AGENDA
CITY OF GLENWOOD SPRINGS
Planning and Zoning Commission
Regular Meeting
MAY 25, 2021
Council Chambers, First Floor
101 W. 8TH STREET
6:00 PM

MINUTES
City of Glenwood Springs
Planning and Zoning Commission
Regular Meeting
August 13, 2020
Zoom
6:00PM

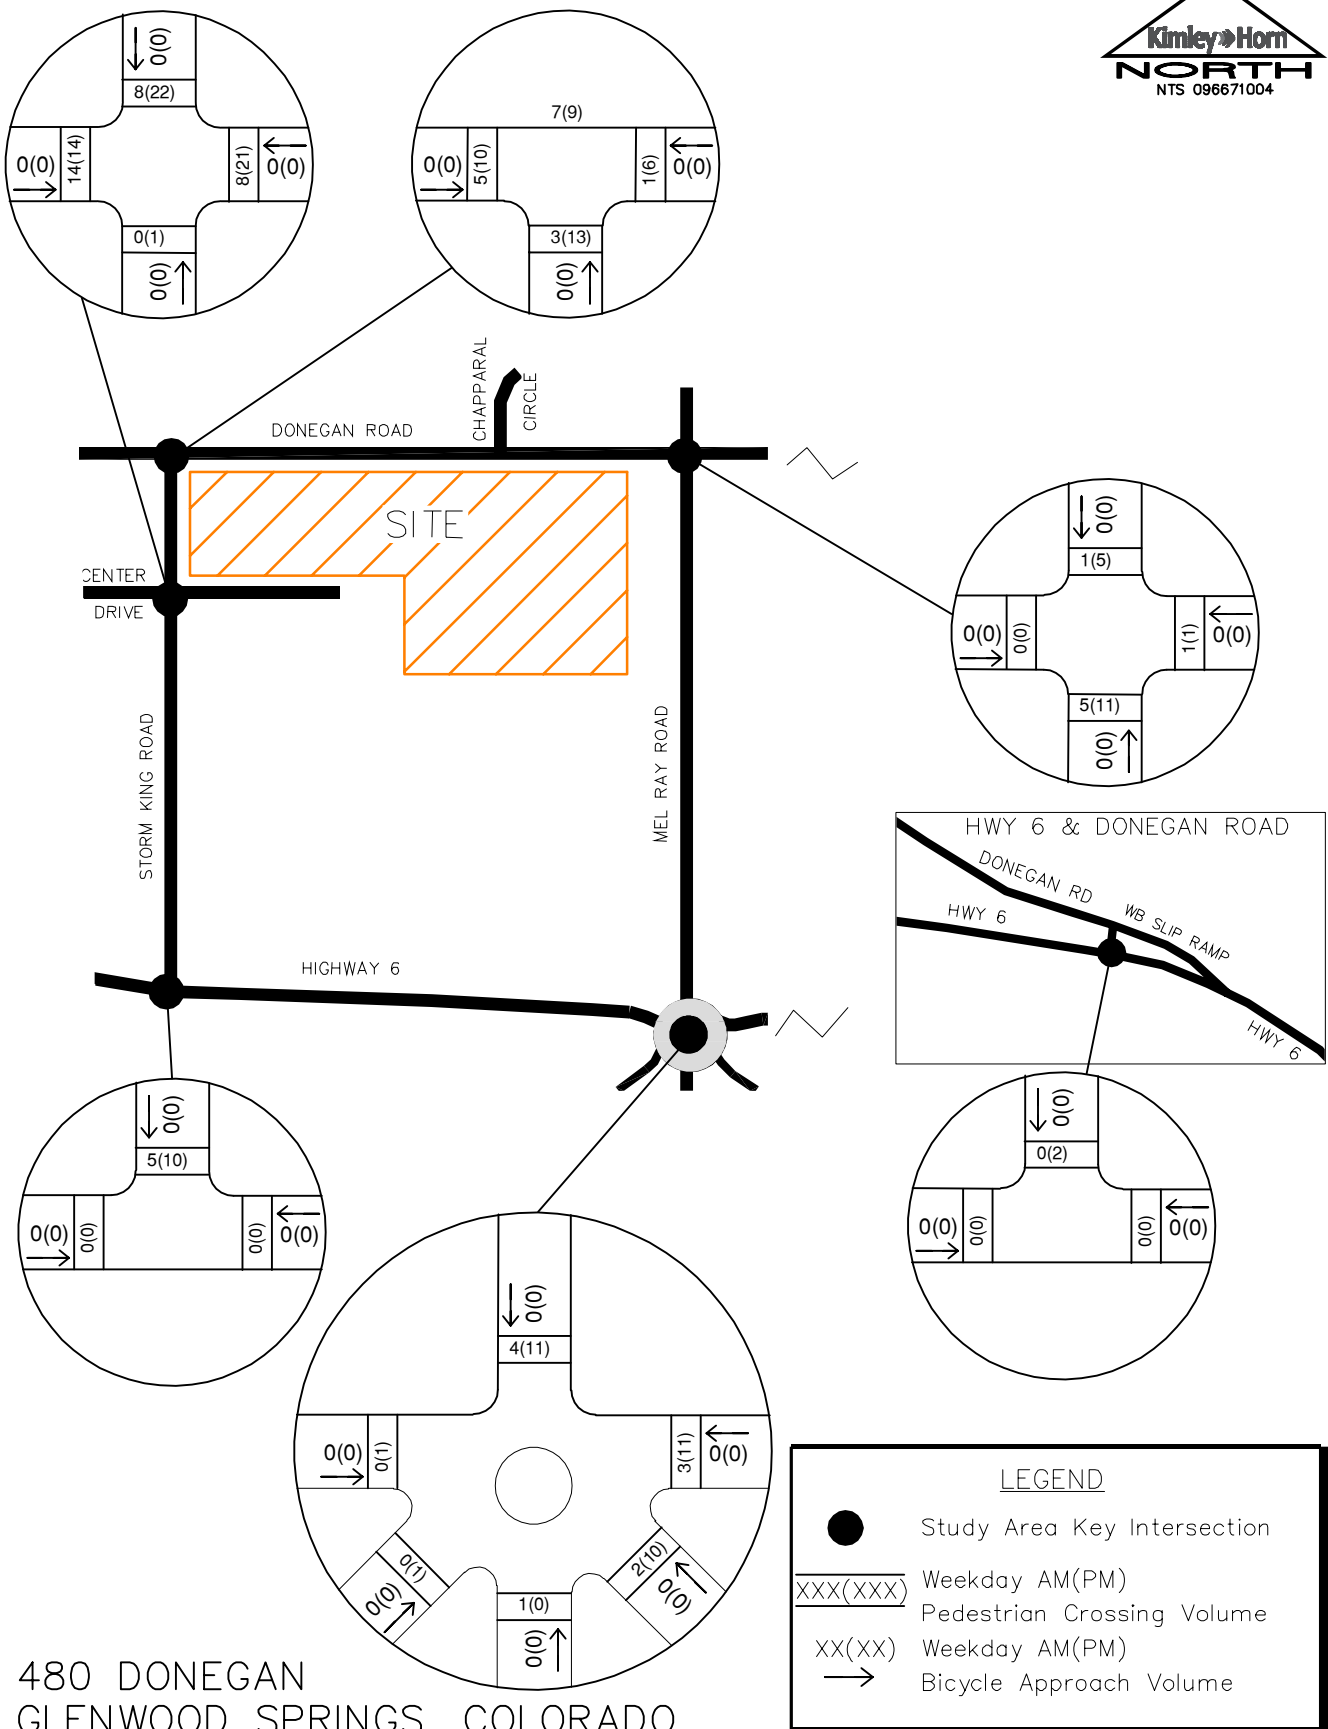
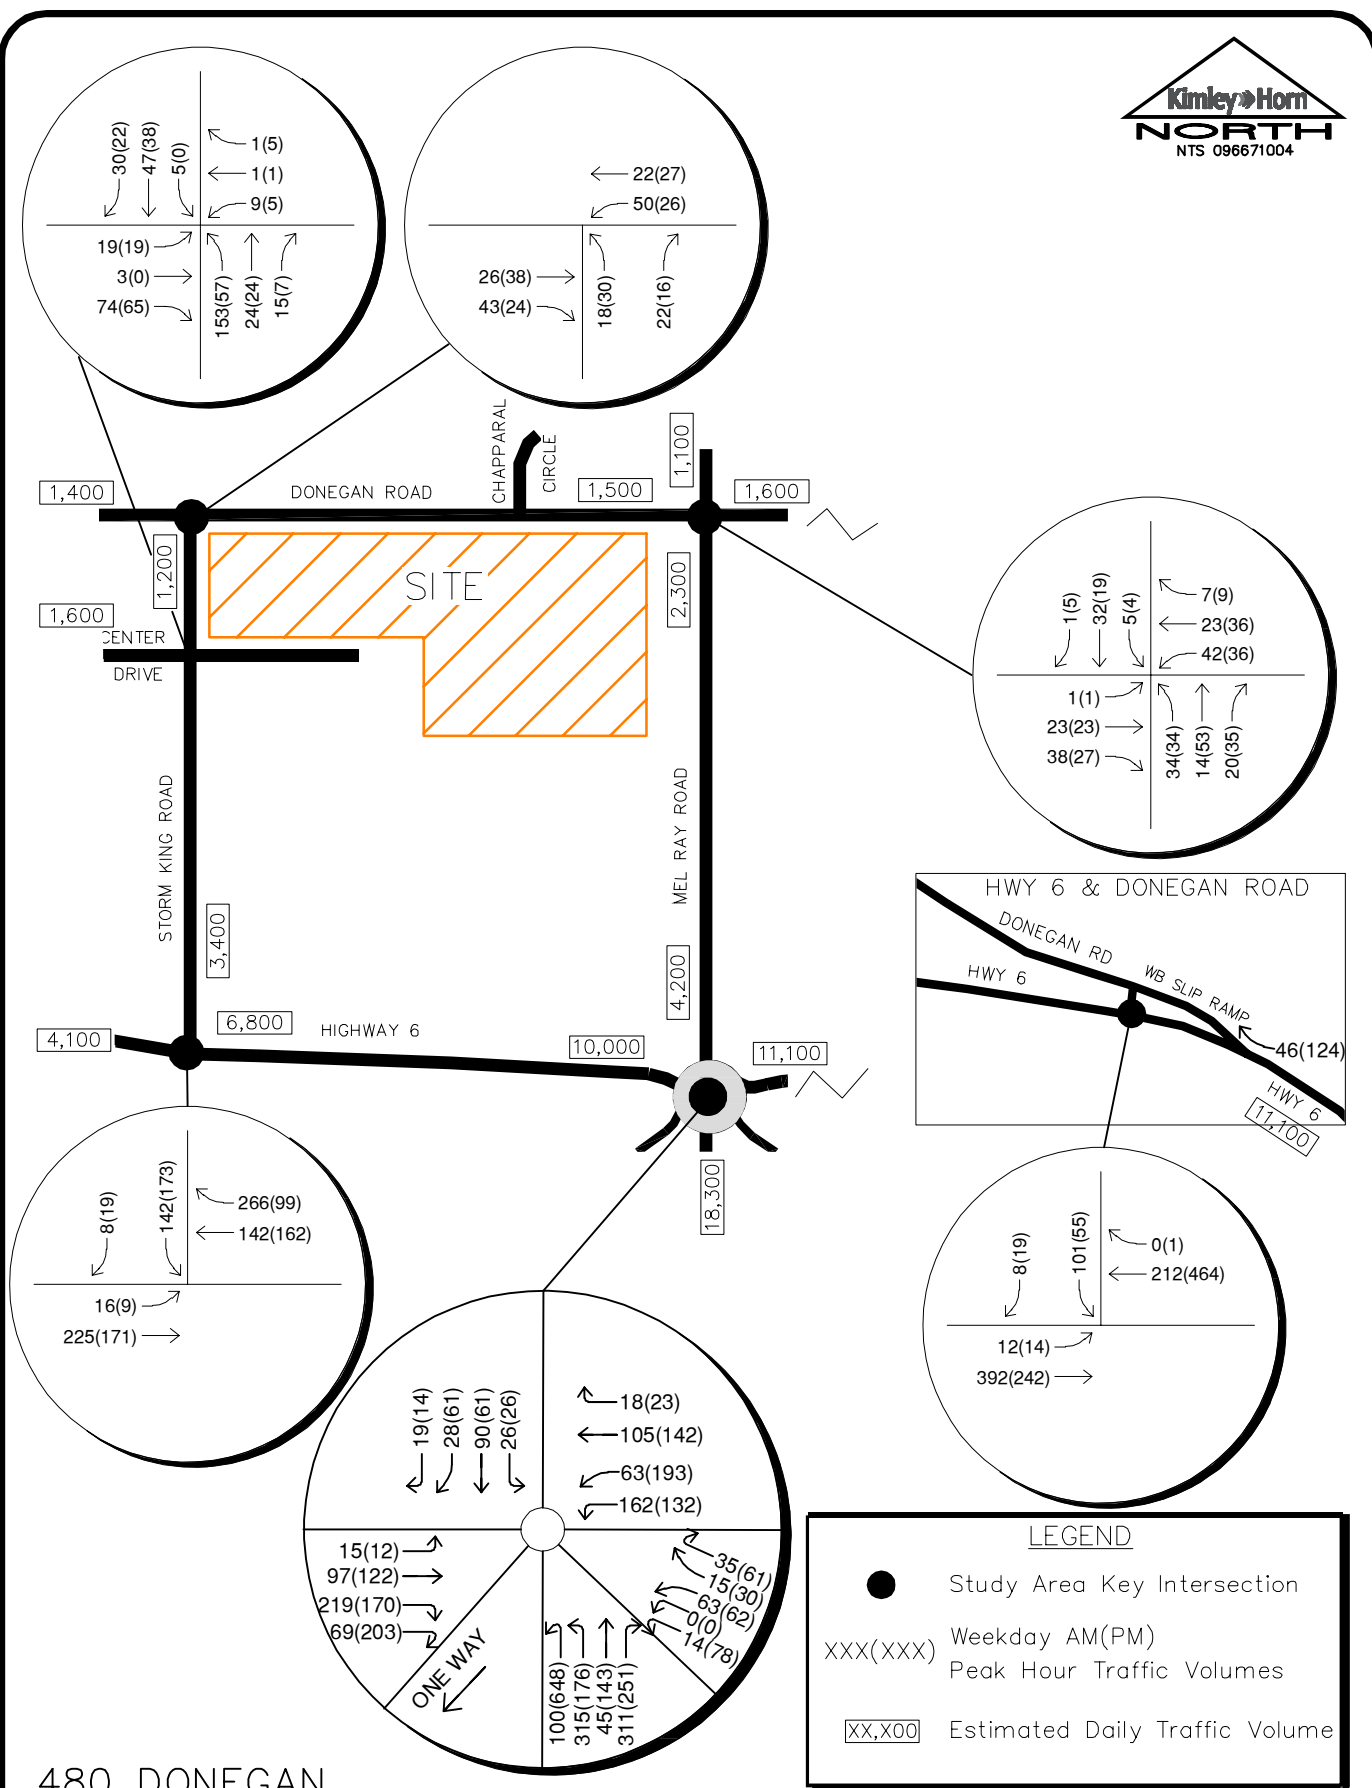
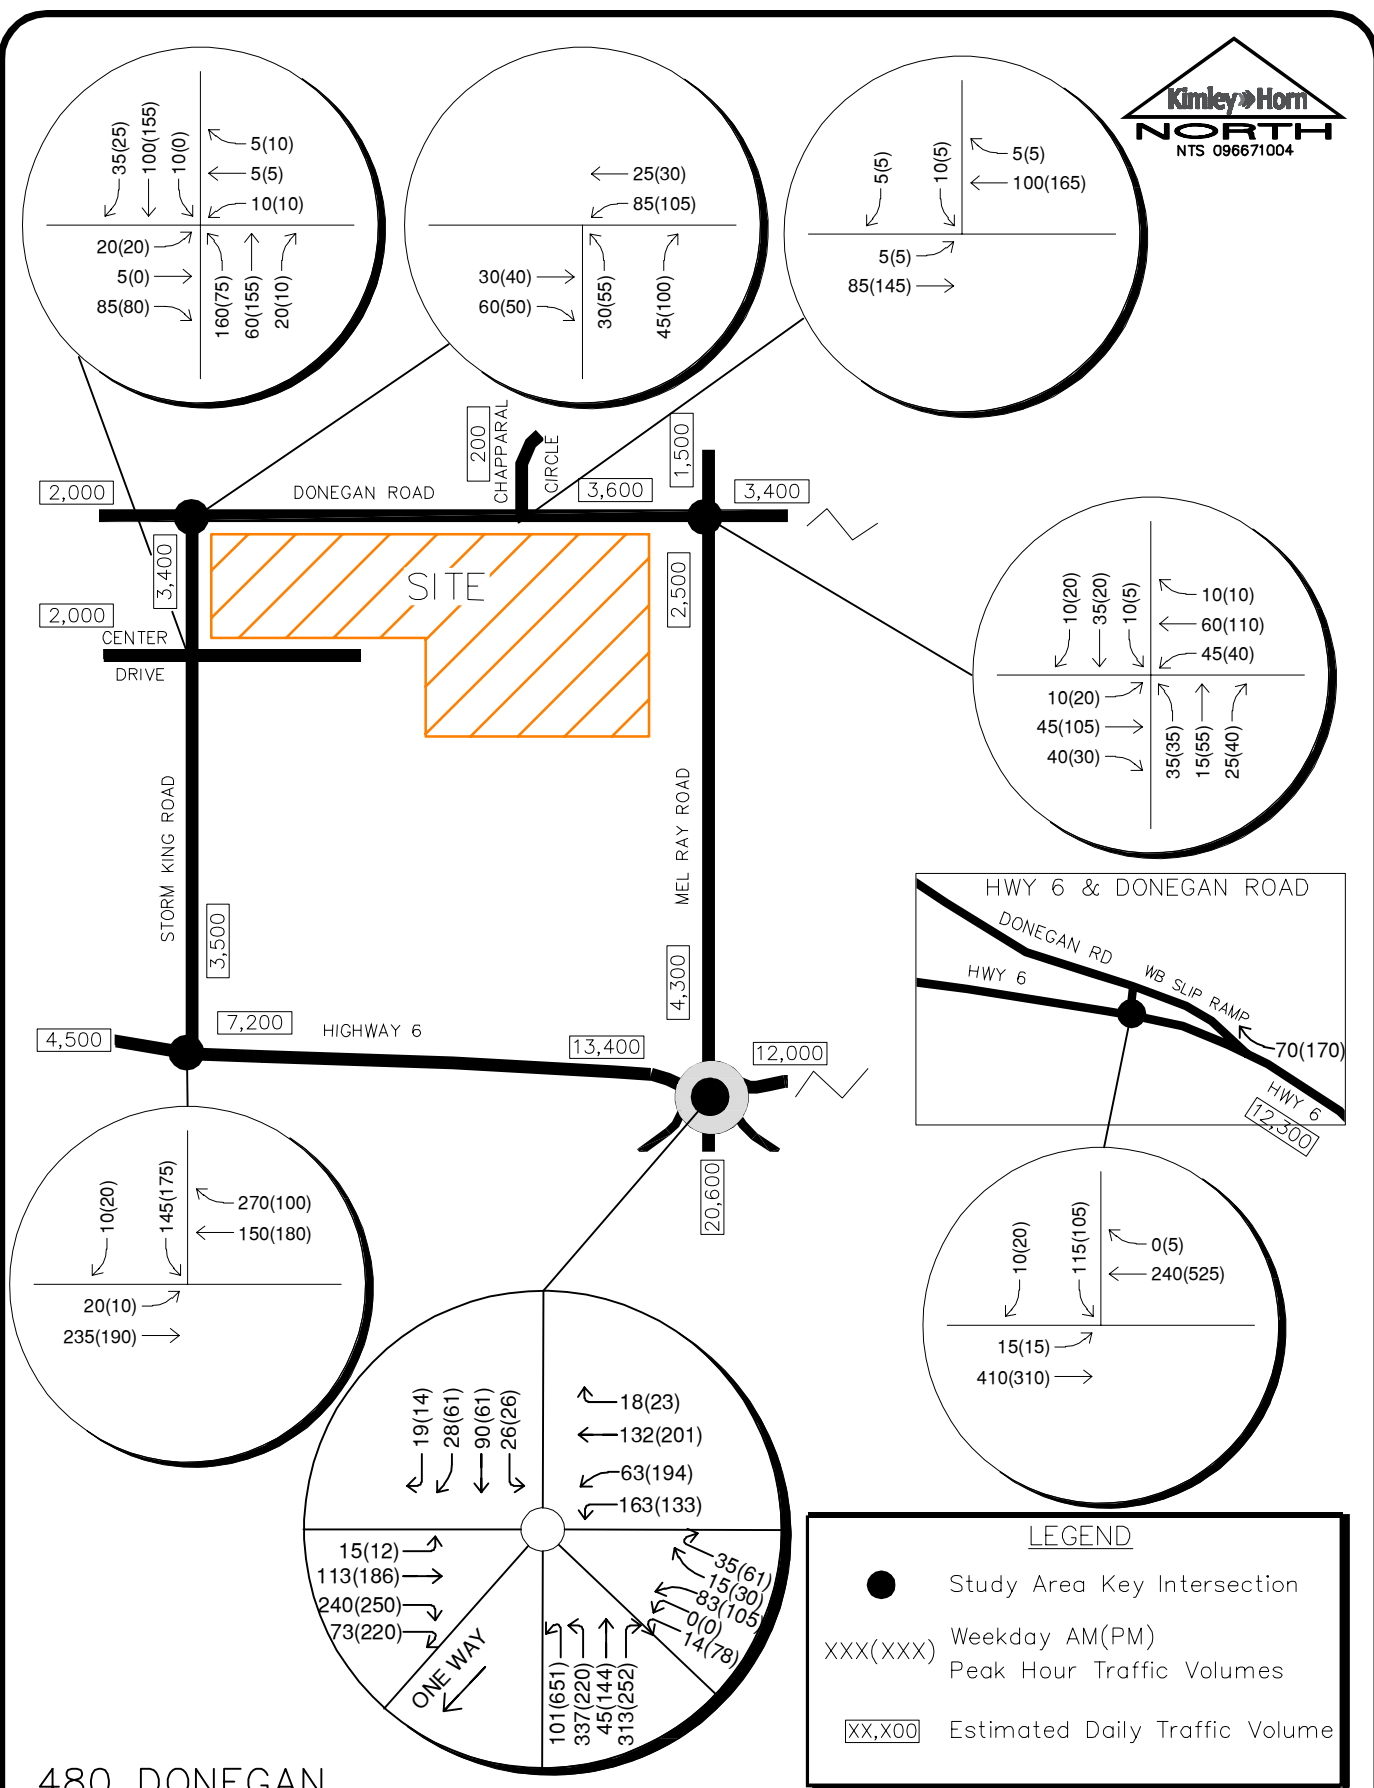
a new Mobile Home Park past Ami's Acres. Figure 7 is inconsistent with the surrounding growth. How come Hwy 6 from Storm King Rd to Mel Rey Road DECREASES from the 2020 Existing Adjusted Volumes – Figure 5 (9500 DTV) to the 2040 Background Traffic Volumes – Figure 7 (8300 DTV) while surrounding roadways/intersections increase? The figures are inconsistent:

Figure 4 (Existing Volumes): HWY 6 DTV = 6,600

Figure 5 (2020 Existing Adjusted Volumes): HWY 6 DTV = 9,500

Figure 6 (2022 Background Traffic Volumes): HWY 6 DTV = 7,700 (**Lower than the 2020 adjusted volumes**)

Figure 7 (2040 Background Traffic Volumes): HWY 6 DTV = 8,300 (**Lower than the 2020 adjusted volumes**)
